May 23, 2019

**Garvin Boward Beitko  
Engineering, Inc.**  
180 Bilmar Drive  
Suite IV  
Pittsburgh, PA 15205  
Phone: (412) 922-4440  
Fax: (412) 922-3223

Subject: Geotechnical Engineering Review of Stability Analyses and Report  
Section of Amsler Ridge Road  
Economy Borough, Beaver County, Pennsylvania  
Garvin Boward Beitko File 19024

**FIGURE 2 – EXCERPT FROM AFOREMENTIONED REFERENCE 2**

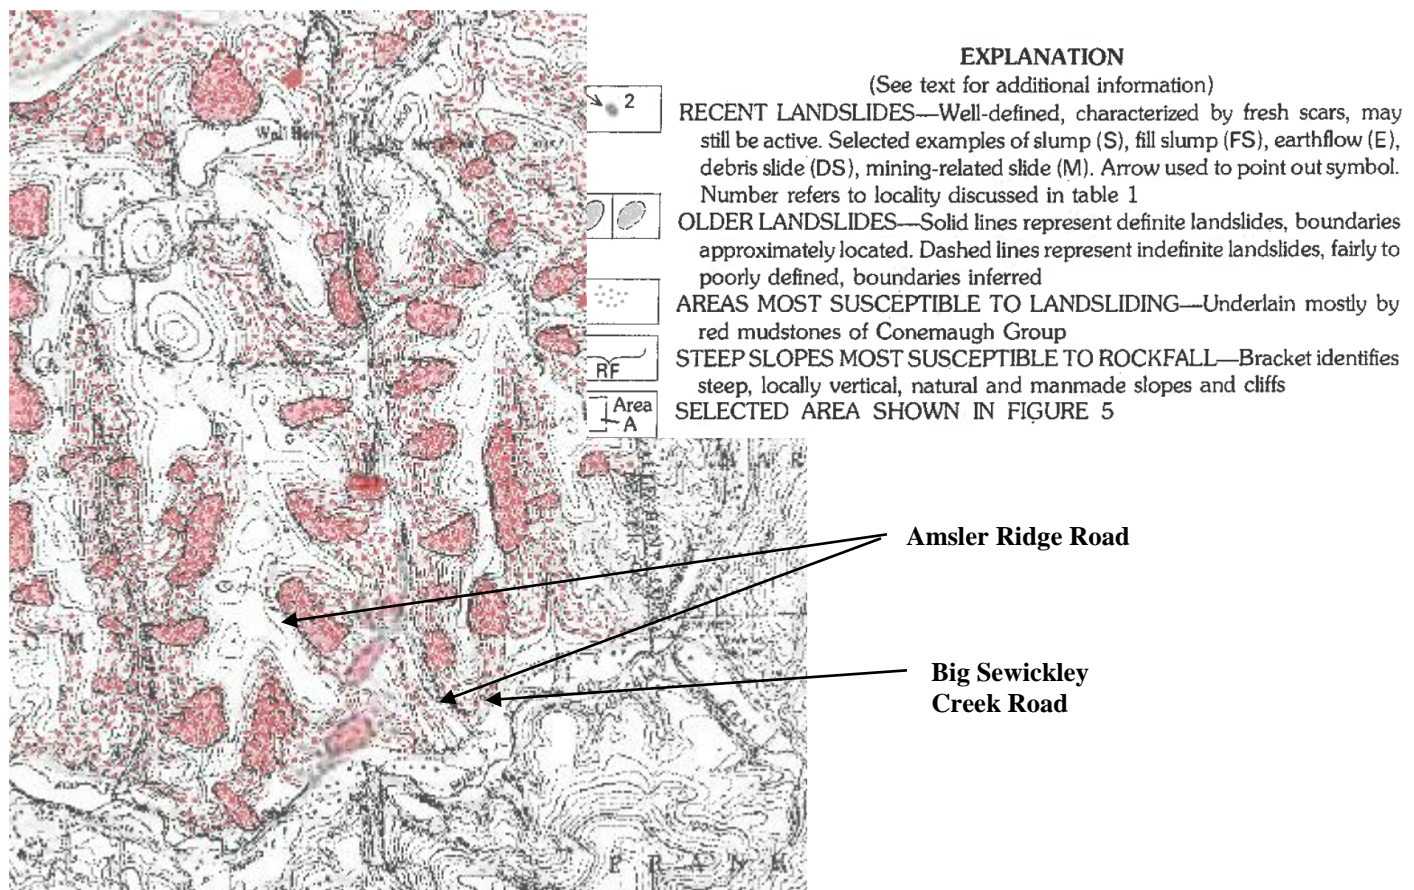
area; primarily areas underlain by claystone, mudstone and shale associated with other rock types. Rock weathers rapidly on exposure forming clayey soil highly susceptible to sliding.” The second reference, an excerpt of which is provided herein as Figure 2, shows the section of the roadway situated in an area deemed to be “Areas Most Susceptible To Landsliding,” therein defined as areas “Underlain mostly by red mudstones of Conemaugh Group.” Reference 2 also shows significant “Older Landslides” areas along the northeastern low-side of the roadway. This reference describes these areas via, “Solid lines represent definite landslides, boundaries approximately located. Dashed lines represent indefinite landslides, fairly to poorly defined, boundaries inferred.” The “Older Landslides” area appears to be generally situated in Zones 1 thru 5.
